[Docket No. 2002–SW–17–AD]

Airworthiness Directives; Eurocopter France Model AS 350B3, SA–365N, N1, AS–365N2, AS 365N3, and EC 155B Helicopters

ACTION: Notice of proposed rulemaking (NPRM).

Figure 1

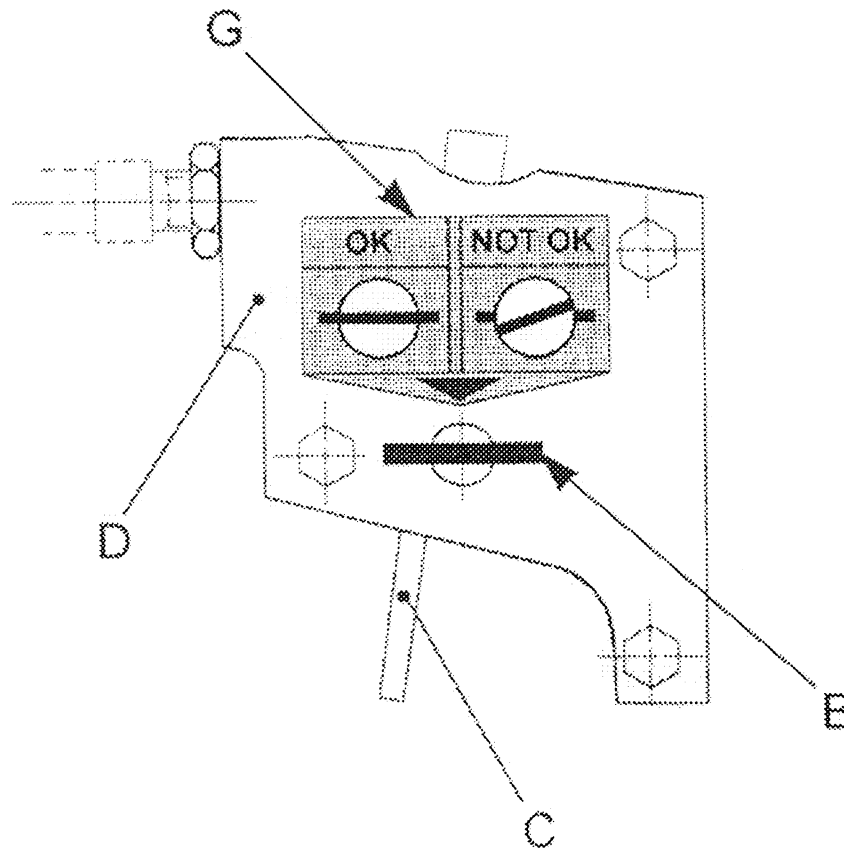
(a) For cargo hook, P/N AS-21-5-7, with Amendment B incorporated, before the first use of the cargo hook on each day that the cargo hook is used, check for corrosion on the locking catch as follows. Amendment B has been incorporated if the letter "B" is marked on the amendment identification plate of the release unit of the cargo hook and placard "G" is installed on the release unit cover plate "D" and reference line "B" is marked over the nut and cover plate as depicted in Figure 1 of this AD. The identification plate is located on cover plate "D", on the opposite side of the electrical connector. See Figure 1:

(1) With the cargo hook installed, cycle the red manual release control lever several times over its travel range.

(2) Return the red manual release control lever to the initial position.

(3) Determine whether the section of reference line (B) marked on the bolt (A) and the section of reference line (B) marked on the cover plate (D) form a straight line.

(i) If the reference line is straight, the cargo hook is considered airworthy.

(ii) If the reference line is not straight, the cargo hook is unairworthy and may not be used.
